Job Name: The Old Power Station Vastern Road
Job No: 47500
Note No: TN005
Date: 9th September 2020
Prepared By: Joe House / Dan Townsend
Subject: RBC Highway 2nd Response

This technical note has been prepared by Stantec on behalf of Berkeley Homes (Oxford and Chiltern) Ltd to provide a response to Reading Borough Council (RBC) highway comments provided in the letter dated 5th August 2020.

The comments provided are in response to the full planning application (ref. 200188) for the demolition of existing structures and erection of a series of buildings ranging in height from 1 to 11 storeys, including residential dwellings (C3 use class) and retail floorspace (A3 use class), together with a new north-south pedestrian link, connecting Christchurch Bridge to Vastern Road.

Design of Access to Southern Towpath

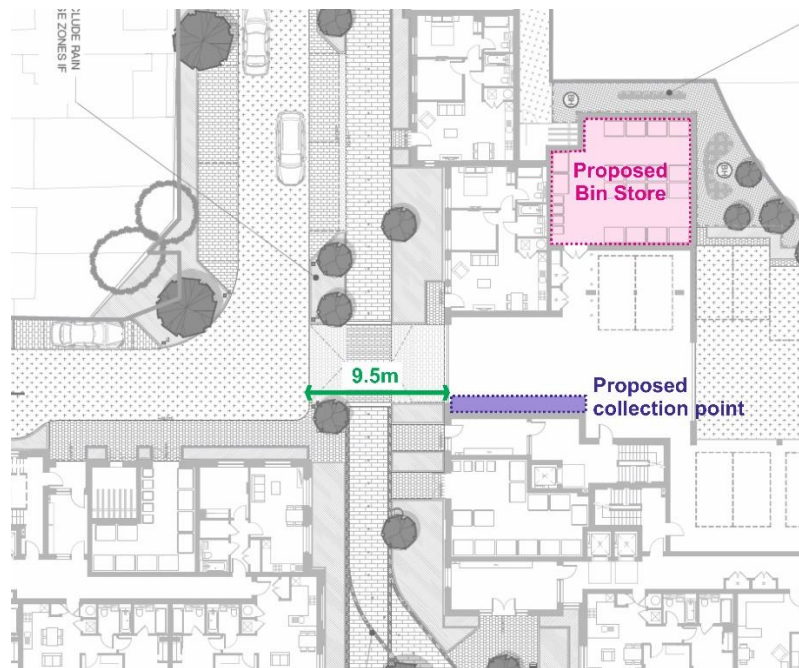
The southern towpath along the River Thames in the vicinity of the proposed connection is not dedicated as a cycle route; as such our proposals have properly been developed on the premise of this being a pedestrian link only. NCN5 actually follows the ramp up to Christchurch Bridge from the east; the cycleway is therefore terminated well before the site boundary is reached. There are also, in fact, physical barriers to the west of Christchurch Bridge to prevent cycling along the towpath close to the site boundary.

The design and gradients that we have been able to achieve mean that it also creates a suitable connection to the towpath for those using wheelchairs or buggies/prams.

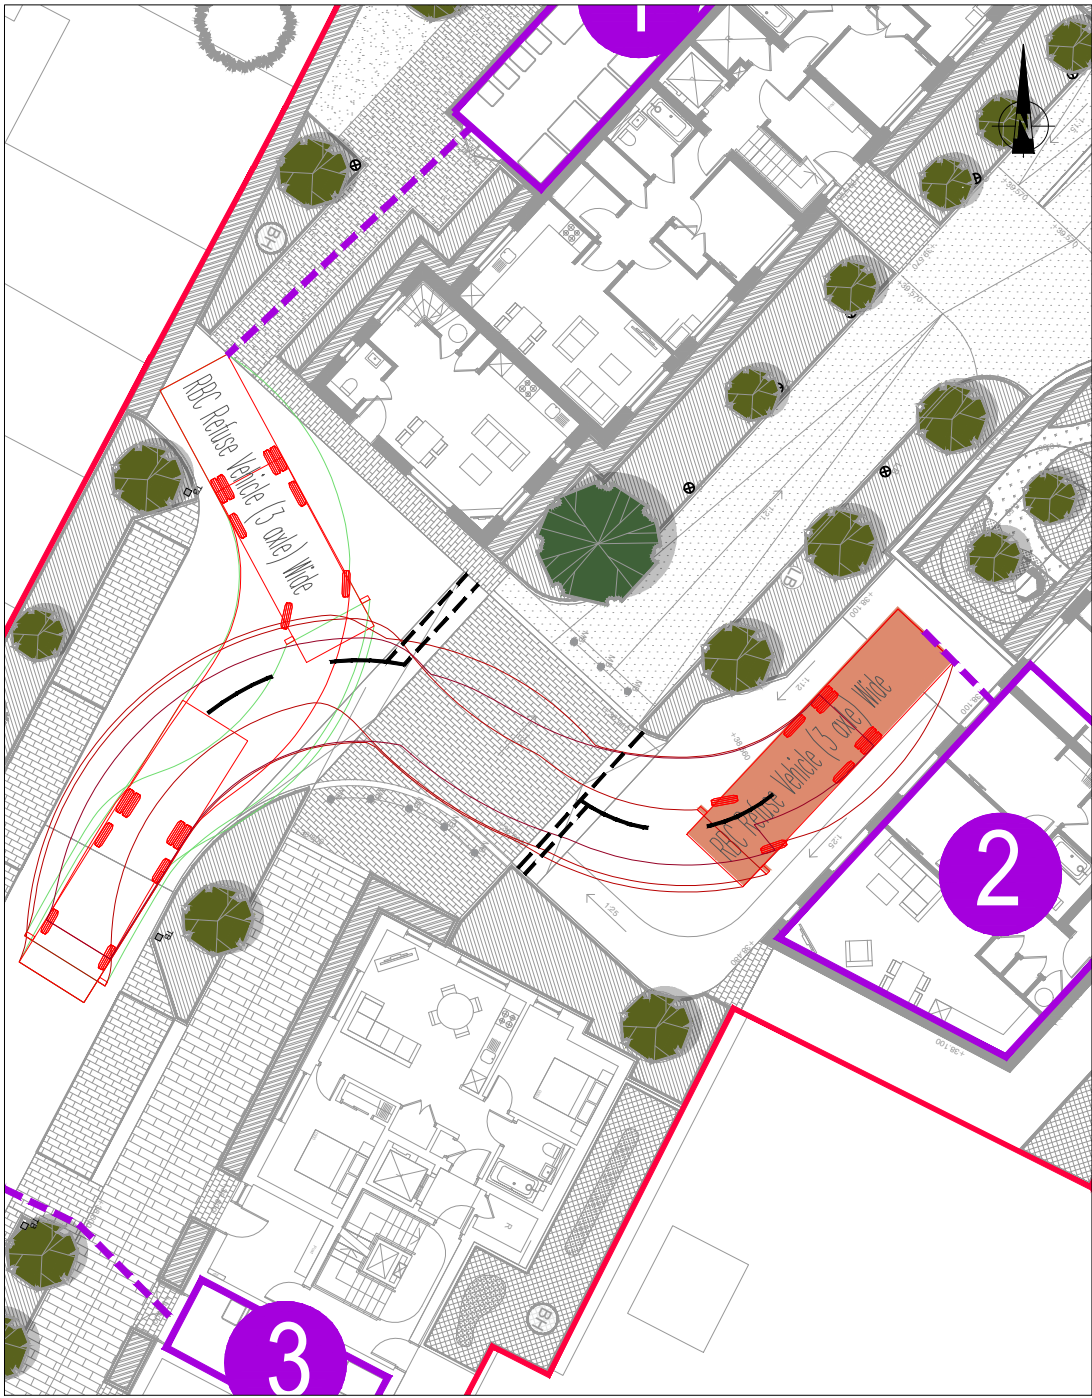
A review of the proposed disabled bays within the site has been undertaken to ensure the maximum distance requirements can be met.

The parking bay within Building B/C parking areas has been reconfigured into to a formal disabled parking bay with 1.2m accessible strip on both sides. This results in a loss of 1 bay in this location.

One of the two on street bays provided along the internal access road has been moved closer to Buildings D and EFG to provide a site wide provision and be more centrally located, as illustrated below.

THE OLD POWER STATION
VASTERN ROAD, READING
INTERNAL TURNING HEAD
SWEEP PATH ANALYSIS

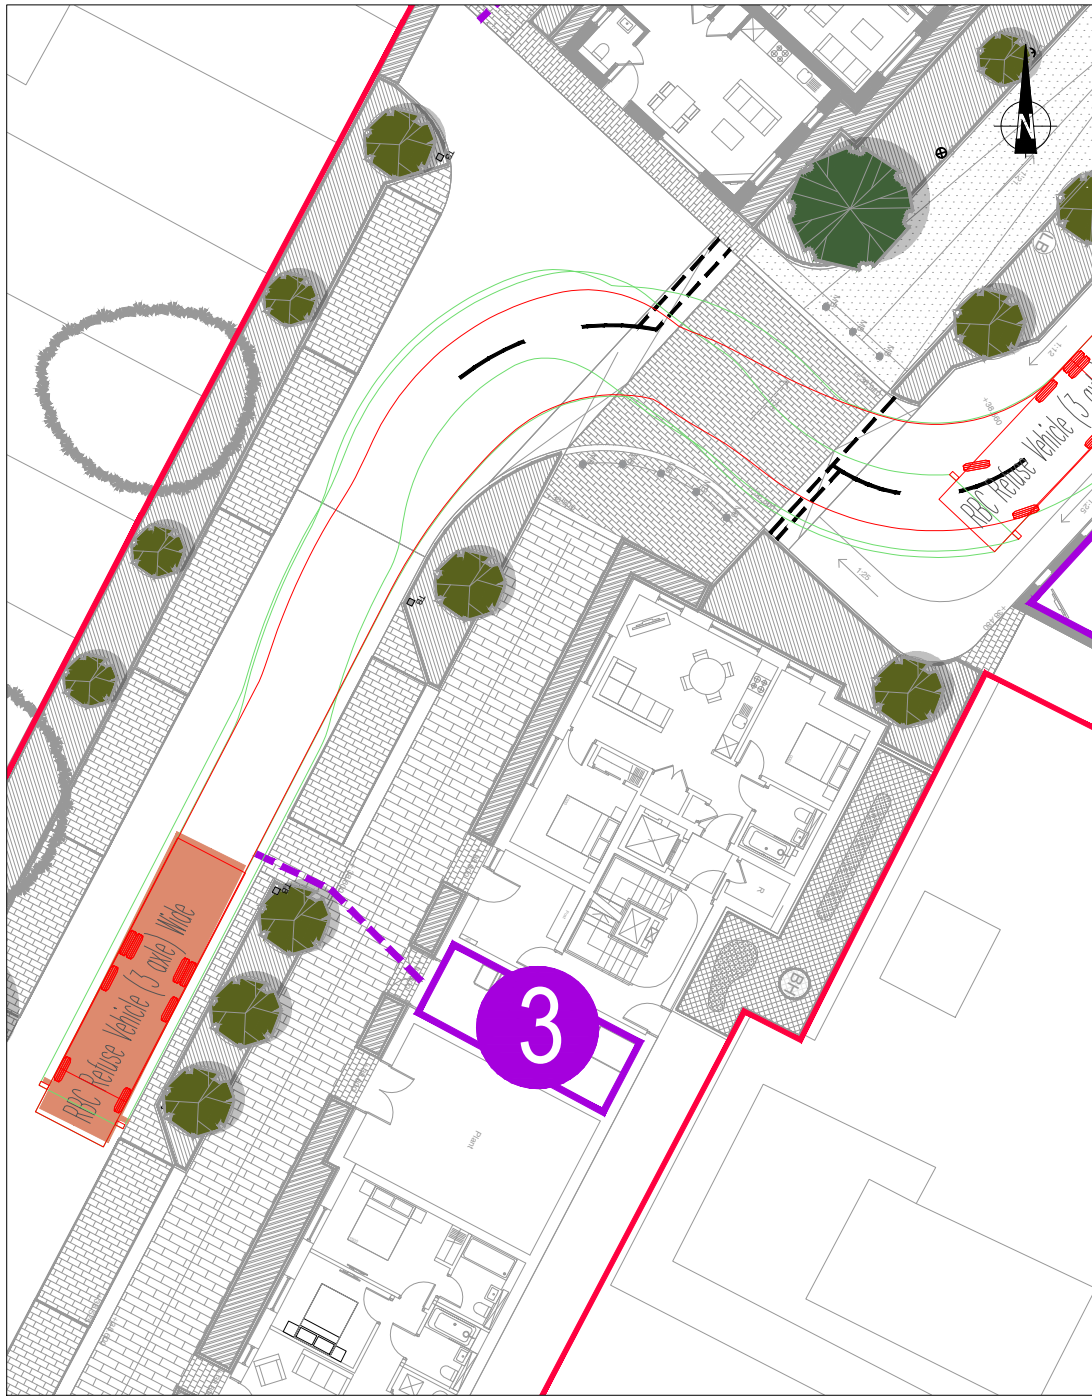
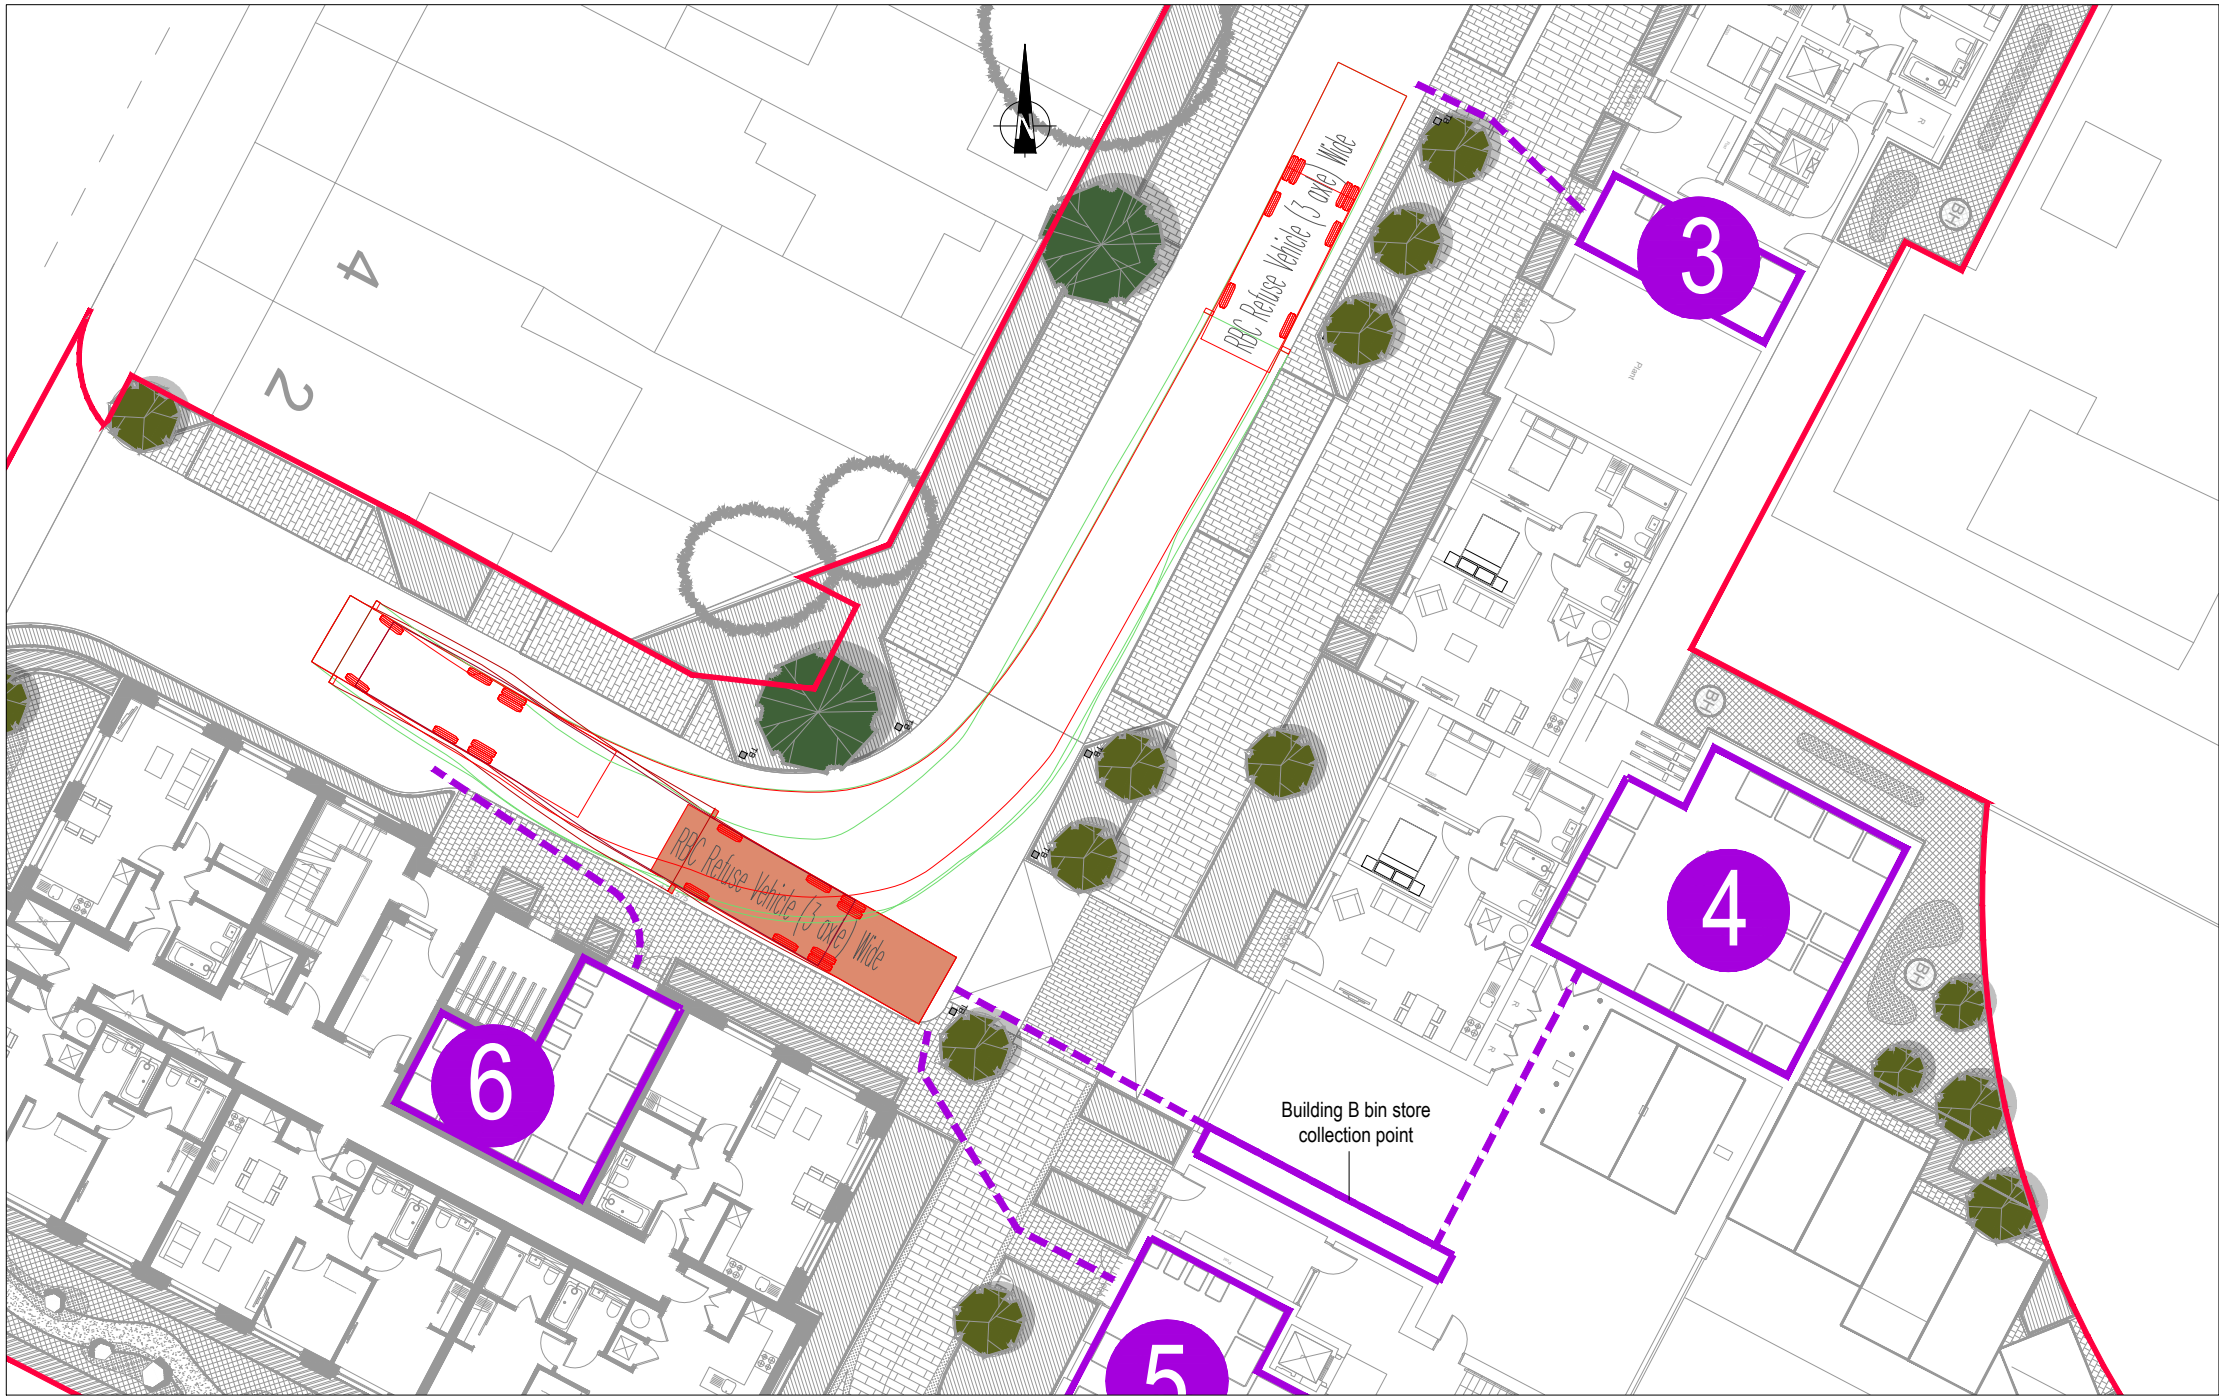
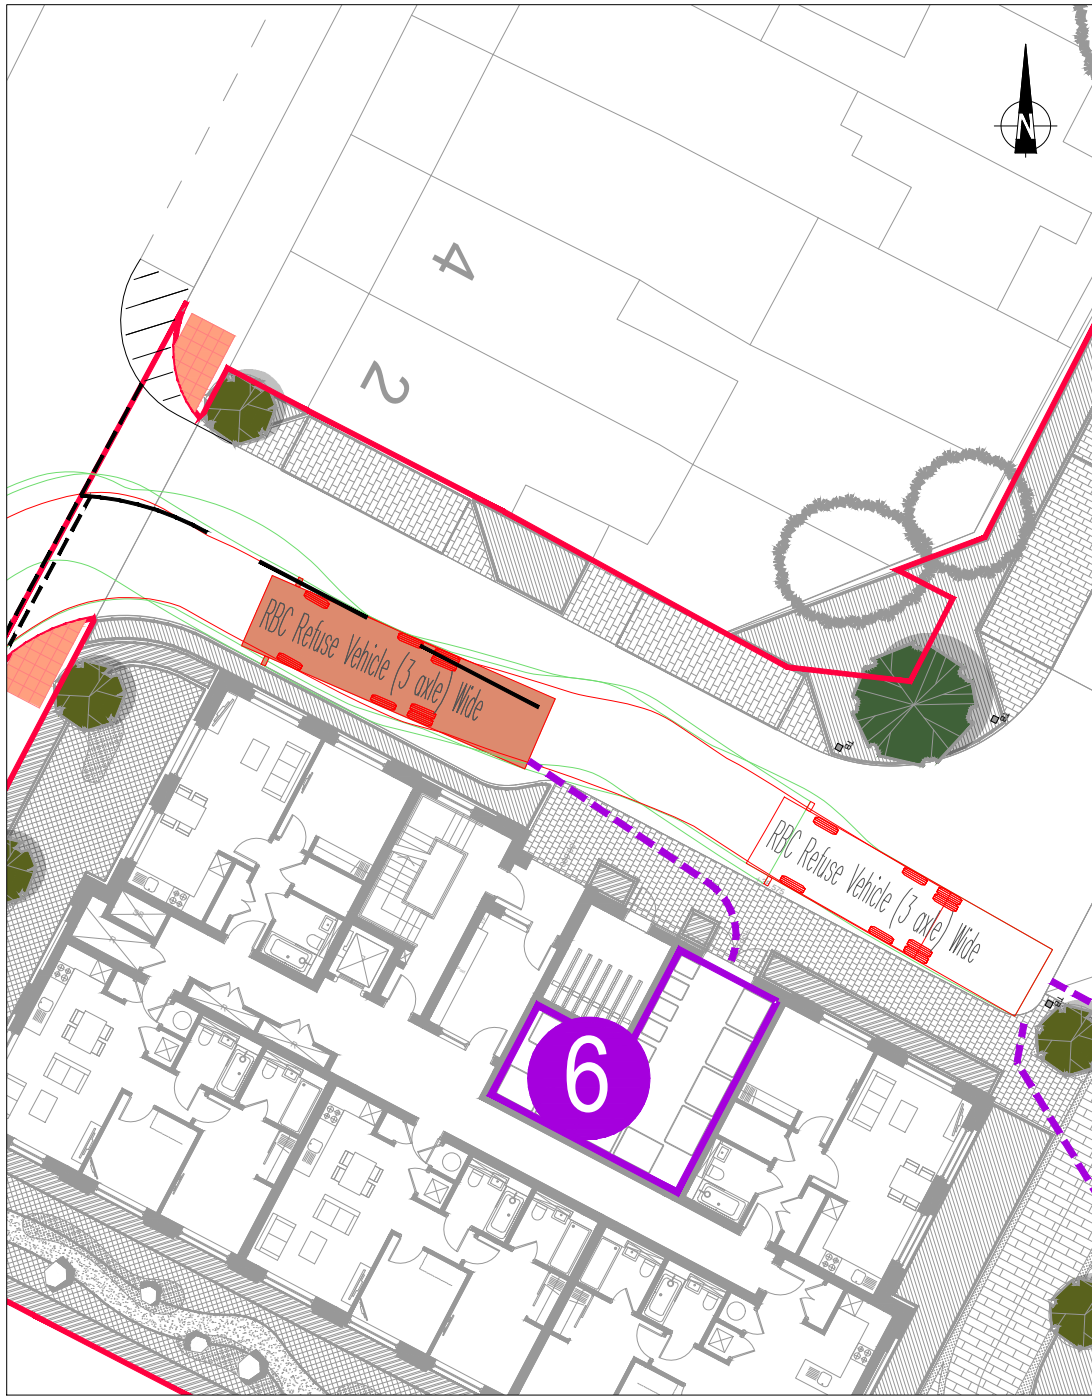
RBC have raised concerns regarding the need for larger refuse and delivery vehicles (HGVs) having to reverse over the proposed dedicated foot/cycleway in order to exit the site and the need for general traffic to cross the foot/cycleway.

To overcome the need for the refuse collection vehicles being stationary over part of the northern crossing we have sought to relocate the collection point for Building D. The revised collection point for servicing is proposed to be taken directly from the undercroft car park access and prior to the shutters. This will therefore mean the refuse vehicles will be located adjacent to the bin store doors which reduces the carry distances for operatives and in turn the time it takes to service the building. This arrangement would no longer require a HGV to be parked on the northern crossing.

A	REVISED ACCESS ARRANGEMENT FOR BUILDING D	08.09.20	JH	DT	SW
Mark	Revision	Date	Drawn	Chkd	Appd
